# CITY OF ALBUQUERQUE

RE: **Lot 4 Block 6 Unit 18, S.A.D. 228**  
**Volcano Cliffs Subdivision**  
**6616 Kimmick Rd. NW**  
**Grading and Drainage Plan**  
**Engineers Stamp Date 12/23/19 (D10D003M4)**

Based upon the information provided in your submittal received 12/24/19, this plan is approved for Grading Permit.

CANDELARIA - GONZALES - GRADING & DRAINAGE PLAN

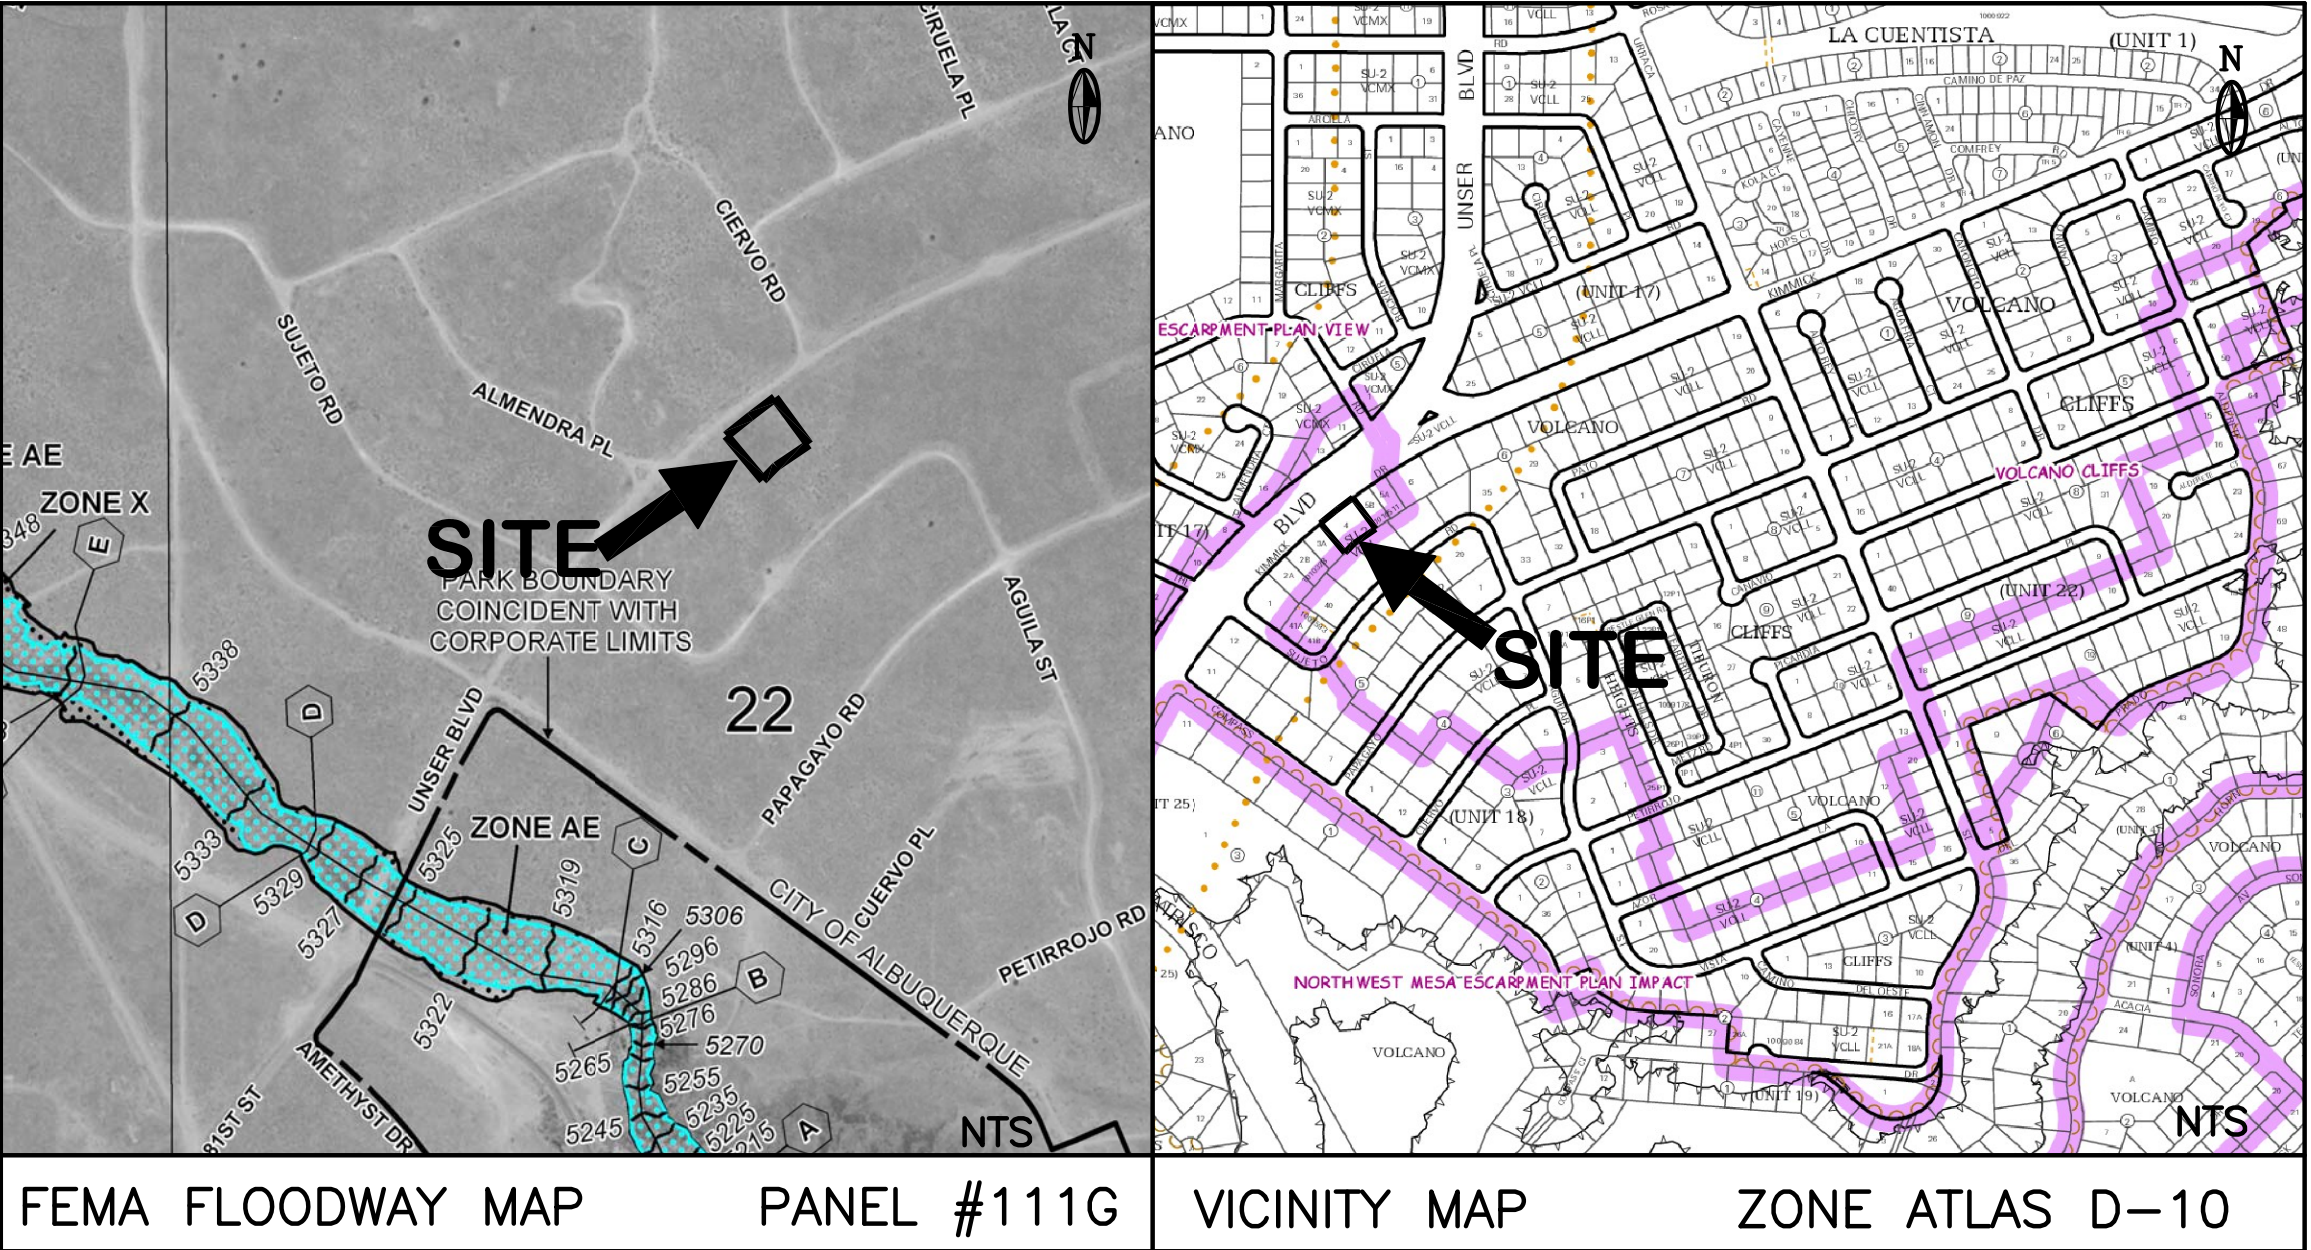
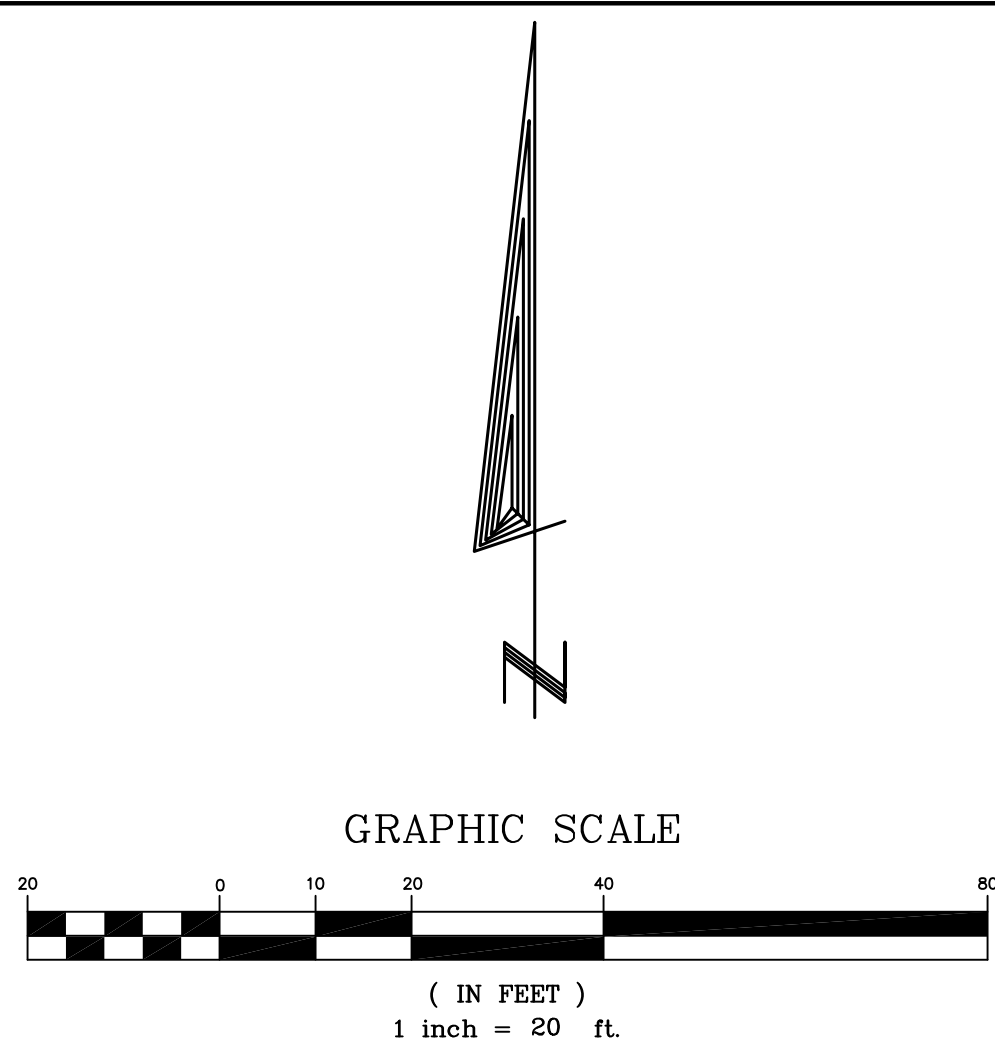
**Prior to Building permit approval a Pad Certification will be required, provided by the Engineer or a registered Land Surveyor.**

Reiterate to the Owner/Contractor that a separate permit for a garden/retaining wall must be obtained, with the approved G&D plan dated 10/28/19.

Prior to Certificate of Occupancy release, Engineer Certification per the DPM checklist of this plan will be required.
